# Access Compliance Report

## Public Rights-of-Way

Intersection ID: 8813	Main Street: JENNINGS_ST	Cross Street: N/A	Location: SW
ADA ID: A53C719C364B	Ramp Type: Perp	Initial Pass/Fail: Fail	Overall Compliance: No
		Severity Score: 25

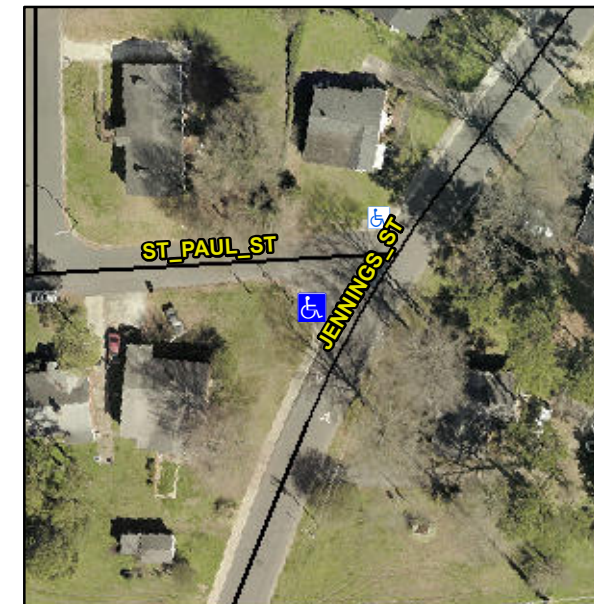
**Not Found, R304.5.3**

Compliance	Description	Data	Compliance	Description	Data
N/A	Ramp Length (in)	58.5	Yes	Ramp Slope (%)	6.3
Yes	Ramp Width (in)	103.0	No	Ramp XSlope (%)	15.0
N/A	Flare Type LT	N/A	N/A	Flare Type RT	N/A
N/A	Flare Slope LT (%)	N/A	N/A	Flare Slope RT (%)	N/A
N/A	Flare Traversable LT?	N/A	N/A	Flare Traversable RT?	N/A
N/A	Landing Length (in)	N/A	N/A	DWS Provided?	N/A
N/A	Landing Width (in)	N/A	N/A	DWS Contrast?	N/A
N/A	Landing Slope (%)	N/A	N/A	DWS Length (in)	N/A
N/A	Landing X Slope (%)	N/A	N/A	DWS Full Width?	N/A
N/A	Landing Curb? (Y/N)	N/A	N/A	DWS Offset (in)	N/A
N/A	Shared Landing?	N/A			
N/A	Gutter Ponding?	N/A	N/A	Gutter Slope (%)	N/A
N/A	Gutter Lip Ht (in)	N/A	N/A	Gutter X Slope (%)	N/A
N/A	Painted X Walk1?	No	N/A	Painted X Walk2?	N/A
	X Walk 1 Direction	To NE		X Walk 2 Direction	N/A
N/A	X Walk 1 Width (in)	N/A	N/A	X Walk 2 Width (in)	N/A
	X Walk 1 Slope (%)	0.7		X Walk 2 Slope (%)	N/A
	X Walk 1 X Slope (%)	7.4		X Walk 2 X Slope (%)	N/A

**Remove & Replace Entire Ramp.**
